Kinross Road Structure Plan

Submission Review Report
September 2011

Figure 3: Location of Acoustic Barriers

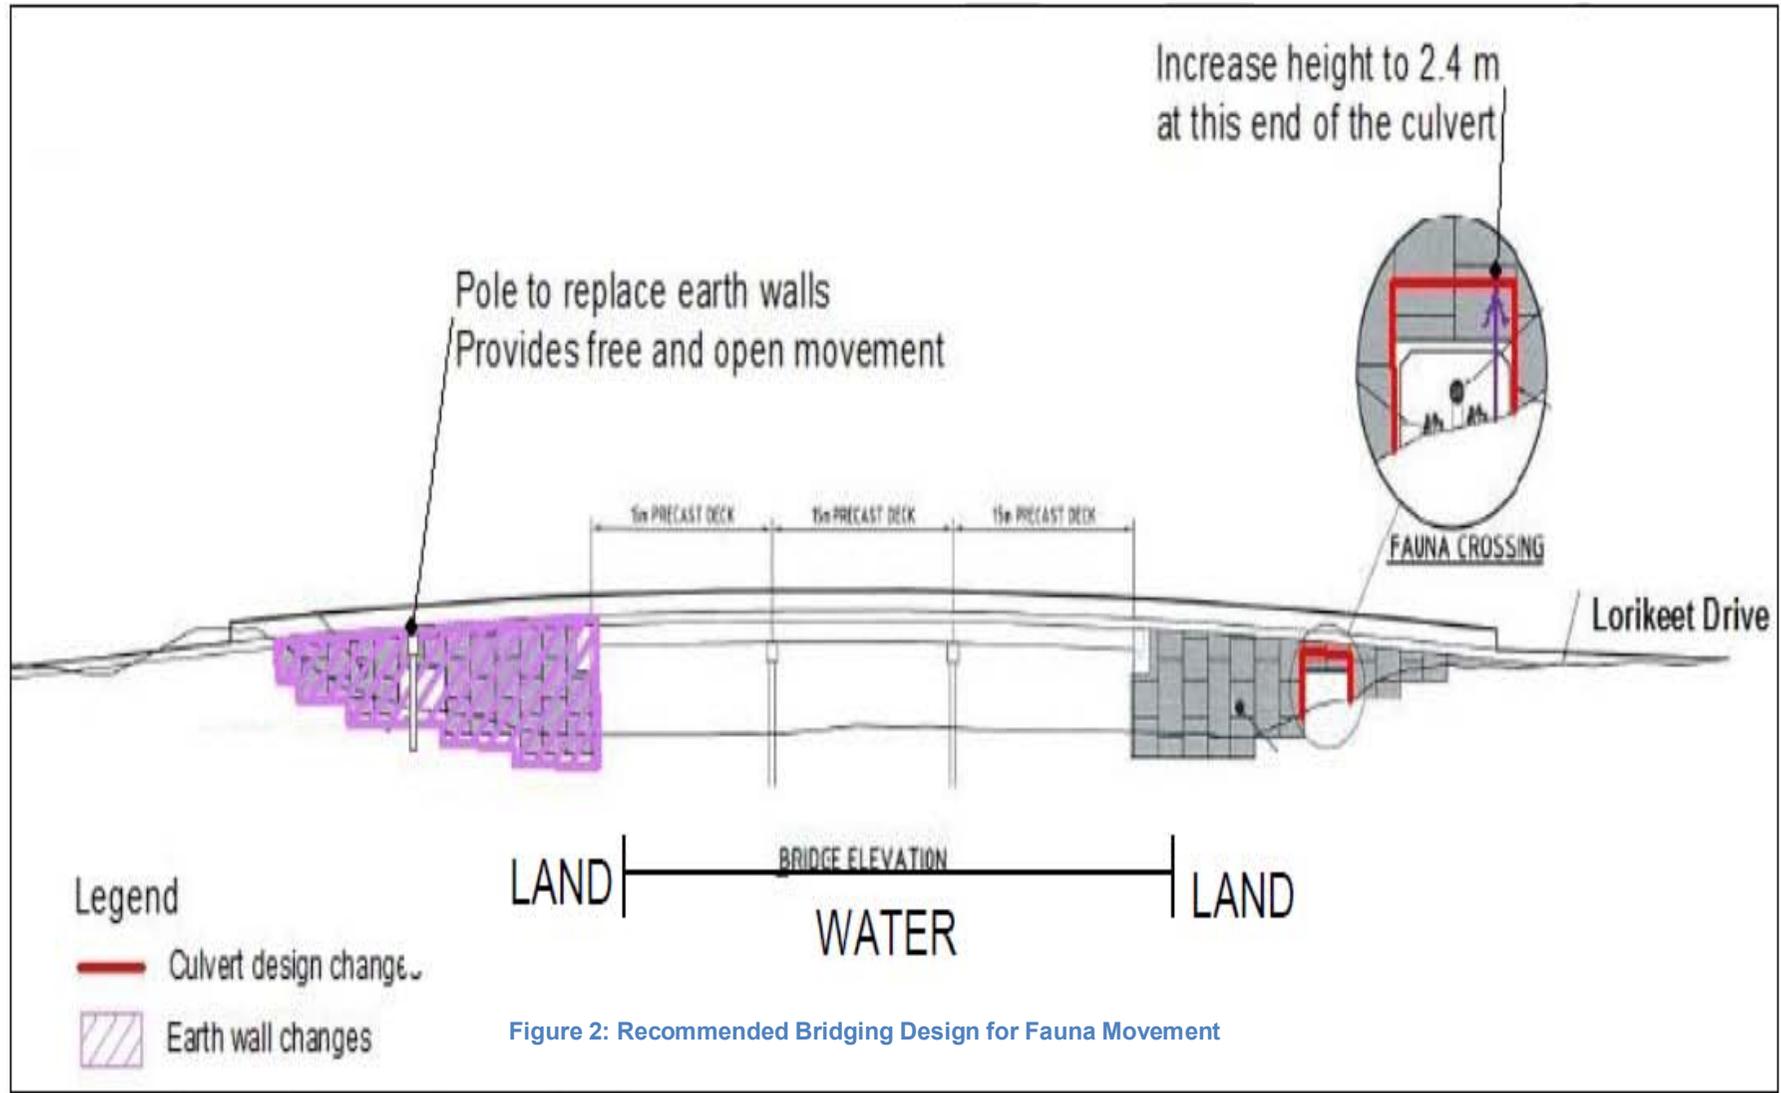
Table 1: Integrated Transport Planning		
Issue Summary	Submission Reference No.	Submission Response
		<p>dwelling floor level, whichever is the highest.</p> <ul style="list-style-type: none"> ▪ 2.0 metre high acoustic barrier along the southern boundaries of 2 Nook Court and 3 Goddard Road. The specified acoustic barrier height is to be above the middle of the potential Goddard Road level or above the adjacent dwelling floor level, whichever is the highest. <p>▪ Any acoustic barrier constructed should be gap free and constructed of materials achieving a minimum surface density of 12.5 kg/m².</p> <p>The location and extent of the recommended acoustic barriers is shown in Figure 3.</p> <ul style="list-style-type: none"> ▪ The Acoustic Report also notes that Council would not legally be required to provide the identified noise mitigation or subject to compensation for the impact of the new trunk collector street. <p>The report also notes that the traffic noise impact on the four houses would be slightly different from the traffic noise impacts on many houses in the City, including those opposite in Panorama Drive adjoining the Ziegenfusz / Panorama Road intersection.</p> <ul style="list-style-type: none"> ▪ Nevertheless, consideration should be given to assisting the owners of these four houses with the necessary noise mitigation measures. For example, it is recommended that if the Goddard Road Deviation is proposed, Council should offer the landowner of 2 Goddard Road an upgrade to glazing on the northern upper level dwelling facade and an appropriate air conditioning/mechanical ventilation system to any habitable rooms off the northern upper level facade.

DRAWN BY: [] CHECKED BY: [] DATE: []		CITY INFRASTRUCTURE 		ZONE: KINROSS ROAD FAUNA CROSSING	SHEET SIZE: A1	DESIGN REFERENCE: []	REV: C1
PROJECT NO: [] DRAWING NO: []		CITY OF REDLAND		TITLE: CONCEPT LAYOUT PLAN	PLAN 1 OF 1	REVISION: []

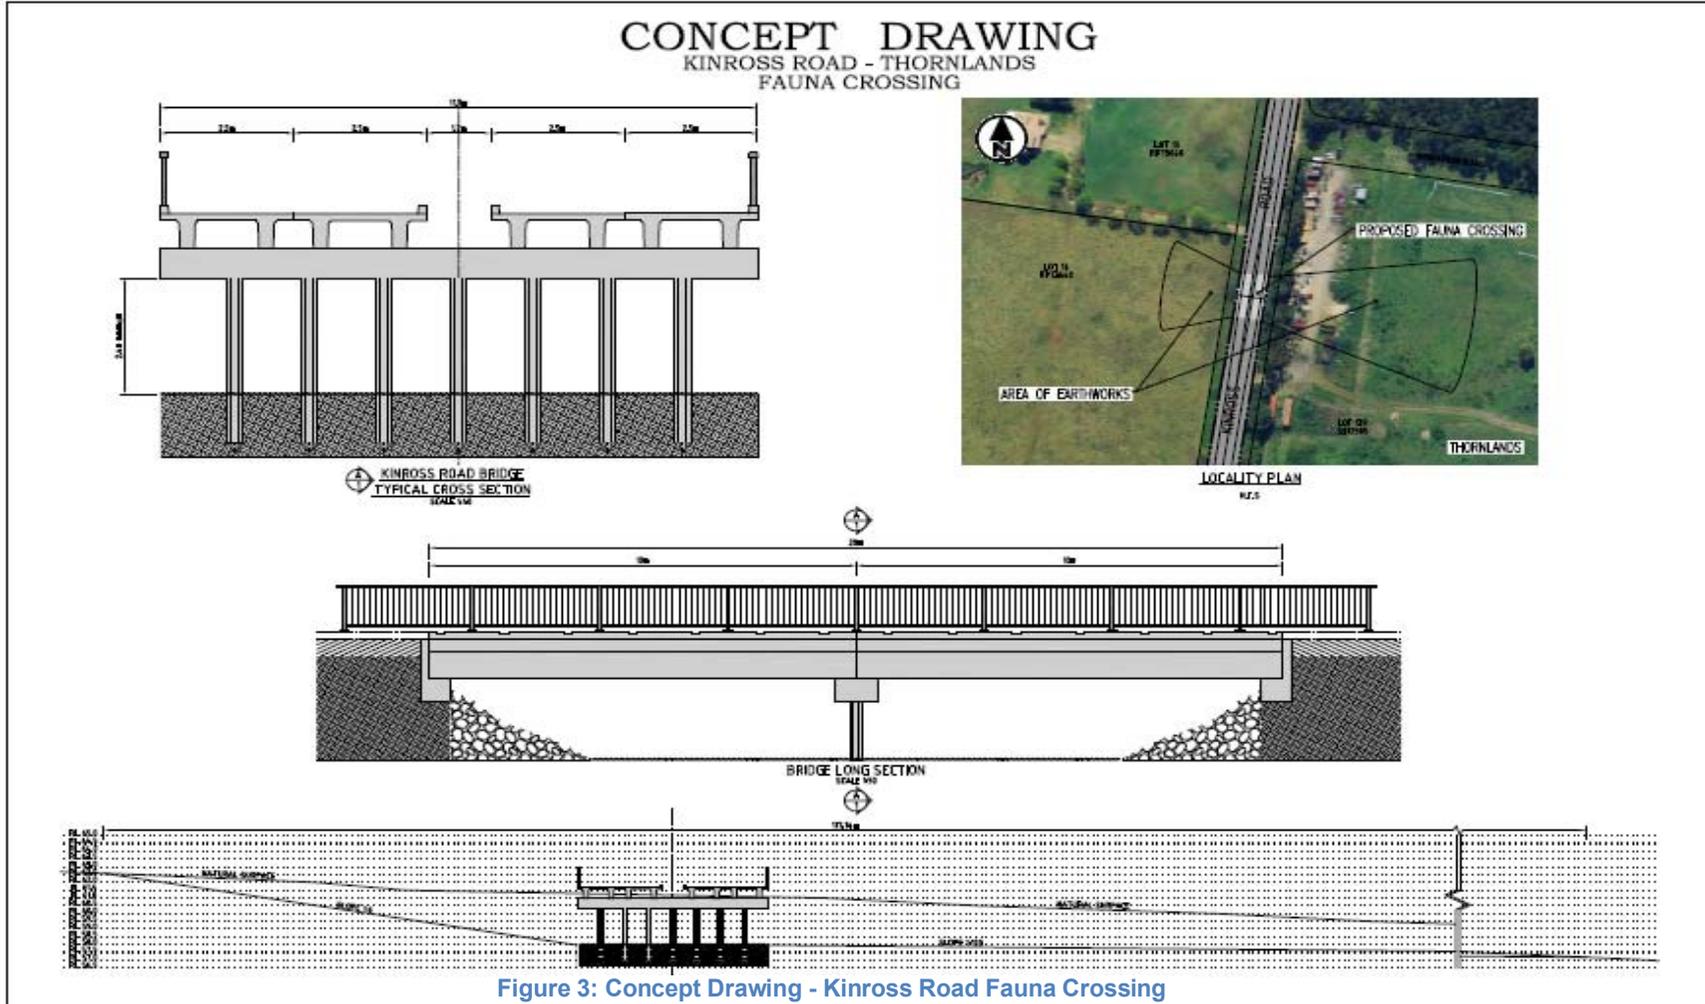
Issue Summary	Submission Reference No.	Submission Response
		<p><i>location along with the location being a high speed and traffic zone of Kinross Road.</i></p> <ul style="list-style-type: none"> ▪ Response: A detailed re-assessment of the proposed fauna crossing location has been undertaken in response to the submitted material. ▪ This re-assessment confirms that a purpose built fauna underpass to provide for grade separated fauna movements under Kinross Road can be cost-effectively engineered in the location identified in the draft Structure Plan. ▪ This fauna underpass concept has been assessed by BAAM. This assessment has re-confirmed that a safe crossing point is essential to support the long-term persistence of local fauna populations but that an overpass would provide for more effective fauna movements (especially for koalas and other arboreal fauna). However, an underpass will also provide for safe fauna movements provided it is of suitable size and is carefully planned, designed and maintained. ▪ A preferred concept design for the fauna underpass has been prepared and reviewed by BAAM (Refer to Figure 3). The conceptual design proposes an open span bridge structure that provides a twenty (20) metre wide underpass crossing with the road platform supported by piers with a break between the lanes provided for natural light. The 2011 BAAM review recommends a number of detailed design and management principles for the underpass to be effective. These can be readily incorporated into the design at the detailed design stage. <p>It is however identified that an underpass may be unsuitable for Gliders. To address this issue it is recommended that</p>

Table 2: Ecological Sustainability		
Issue Summary	Submission Reference No.	Submission Response
		<p>Glider launching poles be installed at either side of the underpass.</p> <ul style="list-style-type: none"> ▪ It should also be noted that the financial costs associated with the construction of a purpose built fauna underpass under Kinross Road to support the local fauna population is warranted recognising the community has placed a high priority on protecting native fauna. For example, significant community support has been received to protect koala populations in the City's urban and bushland areas through the 2007 Koala Summit and more recently Redlands 2030 Community Plan. The Healthy Natural Environment outcome area of the Redlands 2030 includes the following goal and a target to halt the decline of koala numbers then increase to maintain a population of 5,000 koala by 2014: <p><i>'Thriving koala population</i></p> <p><i>Koala habitats are protected and new habitat areas established to support the dietary requirements and roaming nature of bushland and urban koalas.'</i></p> <ul style="list-style-type: none"> ▪ Ground 2 : <i>The central primary corridor traverses steep terrain on the west of Kinross Road that presents a challenge for fauna movements.</i> ▪ Response: BAAM have indicated that a slope is certainly not a problem for fauna including koalas (and other arboreal mammals that climb up trees) or for other fauna, and does not represent a barrier to fauna movement. ▪ It is important to note that the corridors and their location have been developed for all local fauna species, including but not limited to the Koala.

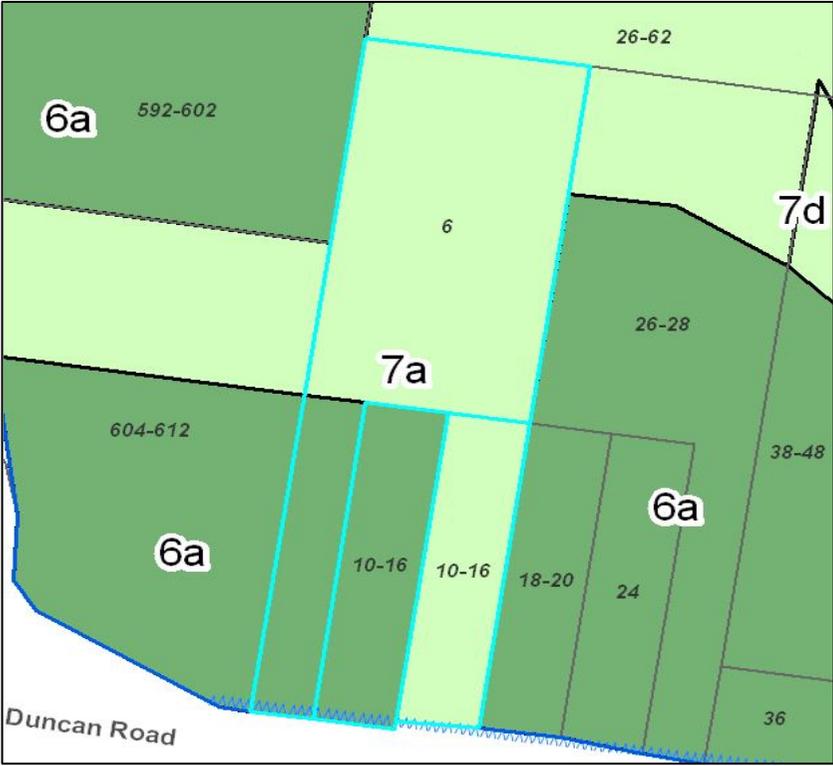
Issue Summary	Submission Reference No.	Submission Response
<p>5.1. 8, 10-16 Boundary Road, Thornlands</p>  <ul style="list-style-type: none"> ▪ General support for proposed draft plan and acquisition of land subject to fair compensation which recognises the loss of the use of the land which will impact on lifestyle and would result in having to move to pursue interest in horses. ▪ Further details on the acquisition process and when purchase would occur is required. 	<p>63, 178</p>	<p>Officer Comments</p>  <p>Source: Kinross Road Public Consultation Land Use Precinct Plan</p> <ul style="list-style-type: none"> ▪ The draft plan currently includes all of Lot 3 on SP118217 and part of Lot 1 on RP849715 within the Greenspace precinct 7a – Hilliards Creek Core Habitat and Corridor. ▪ The intent of the precinct is to provide a connected network of natural areas and accessible open spaces in public ownership comprised of waterways, wetlands, drainage lines,

Table 5: Site specific		
Issue Summary	Submission Reference No.	Submission Response
<ul style="list-style-type: none"> ▪ Koala conservation should be the management focus for the acquired land with additional measures put in place to address koalas trying to cross adjoining DTMR roads. ▪ Current participation in Redland City Councils Waterway Land Management Program (8 Boundary Road). ▪ If purchase price cannot be agreed – request remain in private ownership with a conservation zoning (Lot 3 SP118217). ▪ Request Council also consider purchase of northern part of Lot 2 RP849715. ▪ Indicative bike track – ensure access from existing lots, fencing of private lots to ensure privacy, security and koala safety, motorbikes are prevented from using the track, track can be used by horses. 		<p>parklands, bushland habitats, fauna corridors, and landscape values. Degraded habitats within the Greenspace area are proposed to be rehabilitated to increase native vegetation cover and re-establish fauna corridors.</p> <ul style="list-style-type: none"> ▪ All land proposed for inclusion within the Greenspace Precinct is proposed for inclusion within the Open Space zone of the RPS. ▪ As noted above all land within the Greenspace Precinct is intended to be progressively brought into public ownership through a variety of mechanisms including reasonable and relevant conditions of development approval, infrastructure agreements, and purchase through negotiation and in limited circumstances resumption using revenue sources such as the environment levy (Refer to Submission Review Report 2.5 for more information on Public Ownership). ▪ Existing uses would be expected to continue until such a time as the land is brought into public ownership. Once in public ownership the land will be used predominately for conservation purposes with limited passive recreational uses such as footpaths and bikeways. ▪ Recognising the whole of one lot and a significant portion of the other lot are proposed for inclusion in the Greenspace Precinct and Public Open Space zone under the current plan it is expected the land would in this case be brought into public ownership through negotiated purchase. It should be noted funding for such acquisitions are likely to be sourced from the environmental levy. ▪ Investigations are currently underway to determine acquisition priorities using the Environmental Levy within the

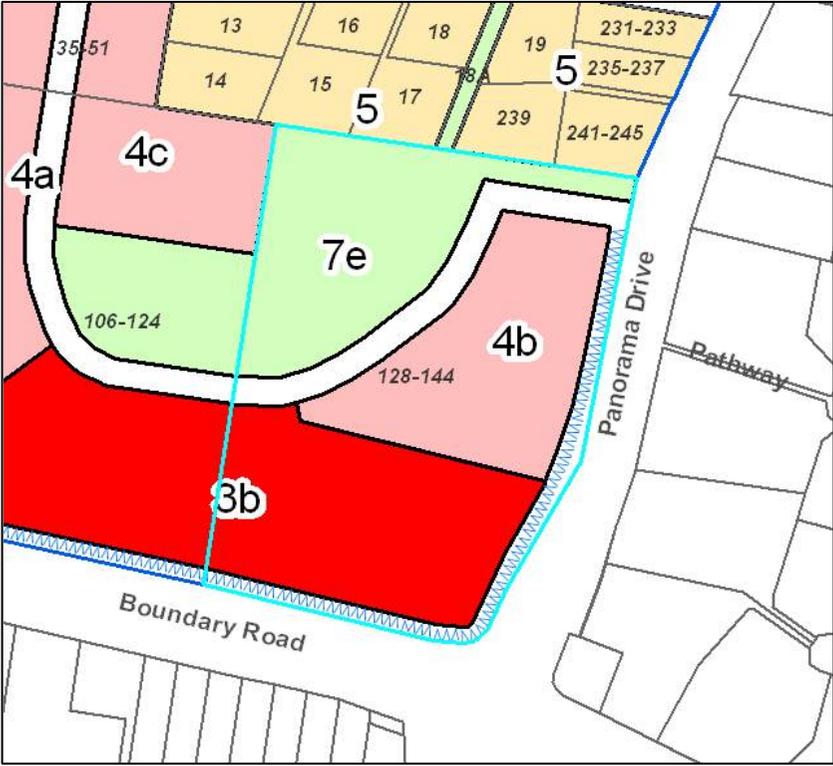
Issue Summary	Submission Reference No.	Submission Response
<p>5.3. 128 Boundary Road, Thornlands</p>  <ul style="list-style-type: none"> ▪ The overall layout of the proposed structure plan does not take advantage of the existing environmental constraints, major road system and access to public transport available to the area. ▪ Current layout is likely to create issues with traffic as the proposed local centre has been placed in an area that is not 	<p>131</p>	<p>Officer Comments</p>  <p>Source: Kinross Road Public Consultation Land Use Precinct Plan</p> <ul style="list-style-type: none"> ▪ The development of the proposed structure plan is supported by a range of technical studies addressing the environmental and ecological constraints, traffic analysis and provision of public transport. The draft plan duly reflects the environmental constraints of the area, the existing major road system and accessibility to existing and planned public transport.

Table 5: Site specific		
Issue Summary	Submission Reference No.	Submission Response
<p>well serviced by existing roads.</p> <ul style="list-style-type: none"> ▪ The site is currently zoned for Local Centre, however this zoning is not retained in the proposed structure plan. ▪ Current code assessable development application over the site is for a shop, commercial office, refreshment establishment and health care centre. Proposed medium density precinct does not reflect the current application. ▪ Medium density housing should be extended across the whole site and the existing residential low density area to the north ▪ Access to the Kinross Road Structure Plan Area should be via Kinross Road and the extension of Carlingford Road. 		<ul style="list-style-type: none"> ▪ The proposed location of the local centre is to encourage a walkable catchment that meets the convenience needs of the surrounding residents. This location will also allow the integration of land uses and create a central area with the Community Facilities Precinct. It is located on Kinross Road and therefore would also serve residents in private vehicles. ▪ The current application will mostly rely on passing commuter traffic and is not within the walking catchment of much of the Kinross road area. If this application is approved it is considered the centre would provide a different purpose to the local centre proposed as part of the draft structure plan (Refer to Submission Review Report 4.1). ▪ A review of the interface treatment and mid-rise medium density precinct along Boundary Road (east of Kinross Road) has been undertaken in response to submissions. The review recommends that the medium density precinct be retained but consistently provided through a low-rise (2 storeys) built form rather providing opportunity for a mid-rise (3 Storeys) built form. <p>This review also recommends that the ten (10) metre strip along Boundary Road for landscaping and acoustic treatments be retained but that the decision on whether this is private or public land be determined through the development application process (Refer to Submission Review Report 3.7).</p> <ul style="list-style-type: none"> ▪ A review of the existing landscaping and acoustic treatments along Panorama Drive has also been undertaken. This review found that a two (2) metre strip of land for landscaping and acoustic treatments have been provided by recent development on the western side of Panorama Drive. To

5.4. 26-62 Kinross Road, Thornlands

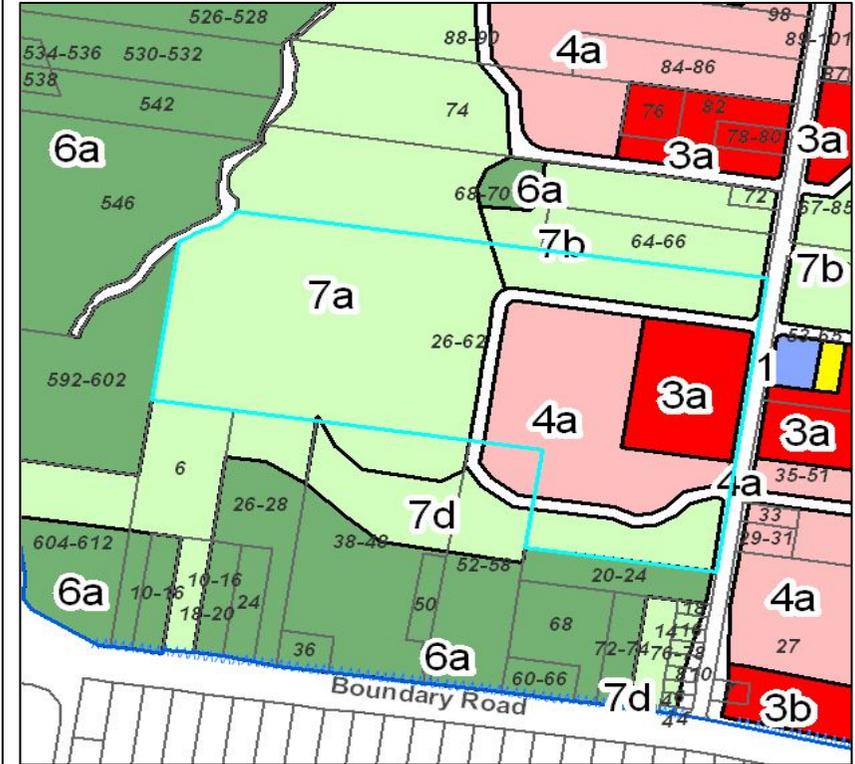
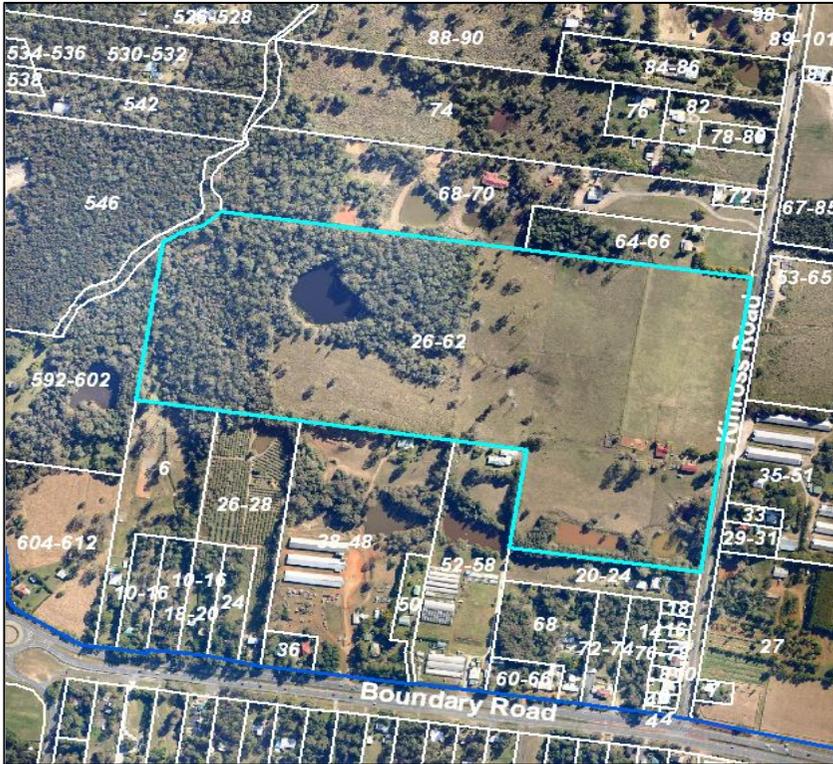
Issue Summary	Submission Reference No.	Submission Response
		<p>to address this matter.</p> <p>(c) The submitter recommends specific outcomes S1.4(2) be amended to – include “(a) provide medium density living options around the mixed use local centre OR and change (a) to (b) and amend as follows “where possible, maximise views and outlook providing a passive surveillance of land in the Greenspace precinct.” The submitters comments are noted and minor changes will be made to the Specific Outcomes to address this matter.</p> <p>(d) The submitter requests a new shaded text box which states – “Note – provision exists for a potential district park with an area of 3.268 hectares to be located in an area marked indicatively on the Structure Plan and will be subject to Council acquisition.” Agree to include additional text box be inserted after Clause S1.9(2).</p> <p>(e) Specific clauses seek to ensure development includes measures to integrate water supply, wastewater and stormwater to ensure the protection of the water cycle and ecological values by –</p> <ul style="list-style-type: none"> (a) Reducing overall water use; (b) Use alternative water sources and substitutes for potable (drinking) water; (c) Minimising wastewater production; (d) Incorporating water reuse infrastructure to maximise recycling opportunities; (e) Protecting waterway health by improving stormwater quality and reducing site run off;

Table 5: Site specific		
Issue Summary	Submission Reference No.	Submission Response
		<p>(f) Minimising impacts on water cycle; (g) Locating to the greatest extent practicable all water, wastewater and stormwater infrastructure outside the Greenspace network (Precinct 7) except where identified in Map 4 – Integrated Water Management.</p> <p>The submitter contends that while this maybe a desirable outcome, these water management strategies are not currently achievable either practically or within the legislative framework. While this concern is noted the clause should be retained. Council will pursue the highest standards achievable under the legislative framework.</p> <p>Officers' Recommendations</p> <ol style="list-style-type: none"> 1. That the submitters note the officers' comments. 2. That the draft Kinross Road Structure Plan be amended to reflect minor changes to clauses in the draft Strategic Framework and Kinross Road Structure Plan Overlay Code as referenced in the Officer Comments. <p>Council Discussion</p> <ul style="list-style-type: none"> ▪ Council supports the officers' comments and recommendations. <p>Special Meeting Resolution</p> <ul style="list-style-type: none"> ▪ Adopt the officers' recommendation.
